# Technical Memorandum

January 7, 2015

Tolend Road Peer Review  
Dover, New Hampshire  
UE Job #1876

Photo 1. Cracking observed in January 2014

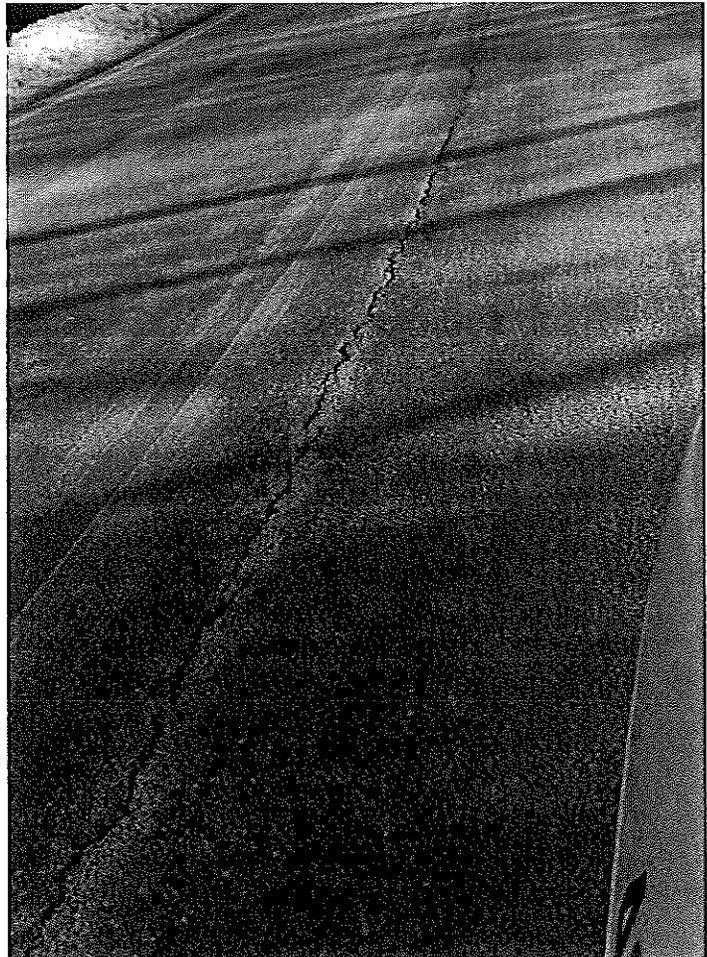
In January 2014, pavement cracking was observed. In July 2014, CMA completed an inventory of the cracking. A draft Change Order was prepared to mitigate the cracking prior to placement of the wearing course.

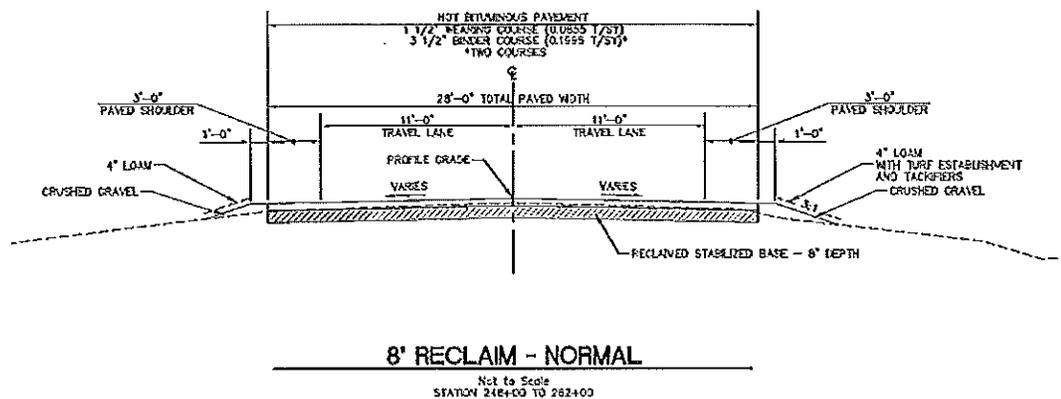
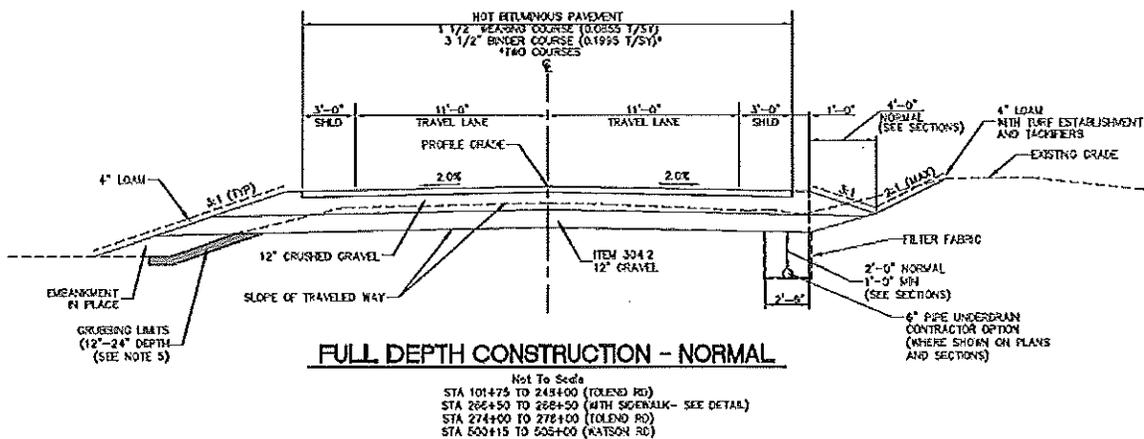
The cross-sections identified a standard 2% crown, except where transitions occurred or where superelevation was designed into the roadway. The longitudinal slope (road

profile) was designed as 0.3% for much of the roadway near the Barrington end of the project. Maximum longitudinal slopes were 6%.

The roadway was raised in much of the project area especially near the Barrington end. Underdrains were incorporated into the design in certain areas. A total of 2,300 feet of underdrain was specified in the Contract and they were reportedly installed per design.
